CITY of NOVI CITY COUNCIL

**Agenda Item 3
March 12, 2012**

SUBJECT: Consideration of the request of Cunningham Limp for Preliminary Site Plan and Stormwater Management Plan approval for a proposed Hyatt Place Hotel. The subject property is located north of Grand River Avenue and west of Taft Road at the existing Suburban Collection Showplace site, in Section 16 of the City. The property totals 48.23 acres and the applicant is proposing a 6-story, 128 room hotel.

**SUBJECT: Hyatt Place Hotel at Suburban Collection Showplace, SP#11-44A,
Traffic Review of Revised Preliminary Site Plan and Traffic Study**

Mark-Up by
Birchler Arroyo
Associates, Inc.

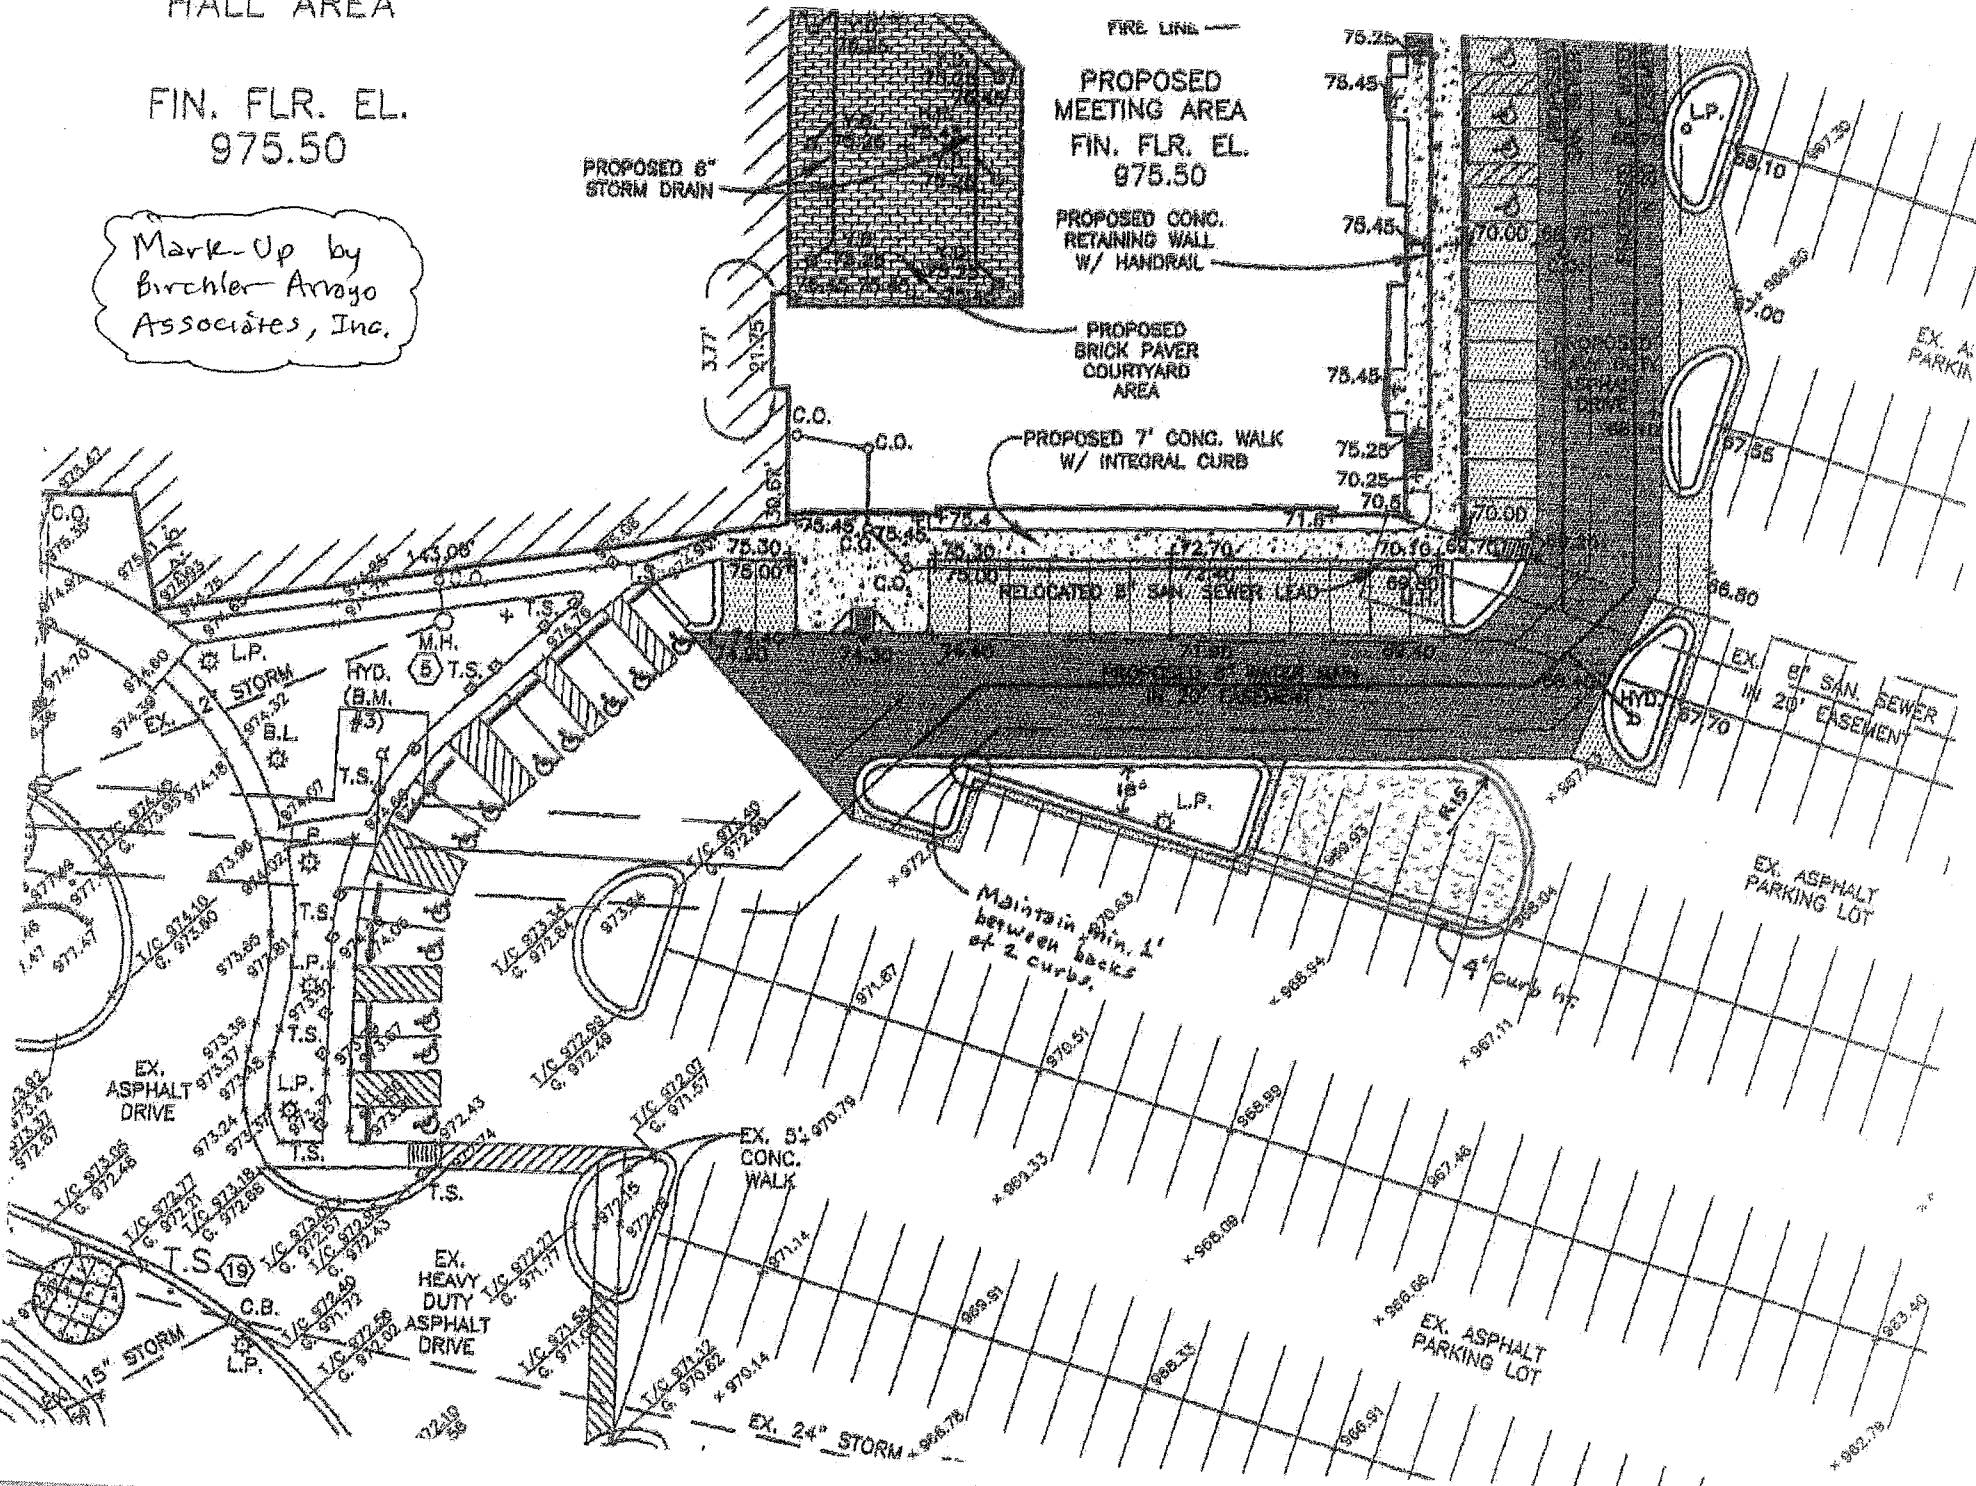
We strongly recommend that the above concerns be mitigated by extending the island as shown in our attached mark-up of the pre-application site plan. This concern is the reason we are recommending against approval of the preliminary site plan.
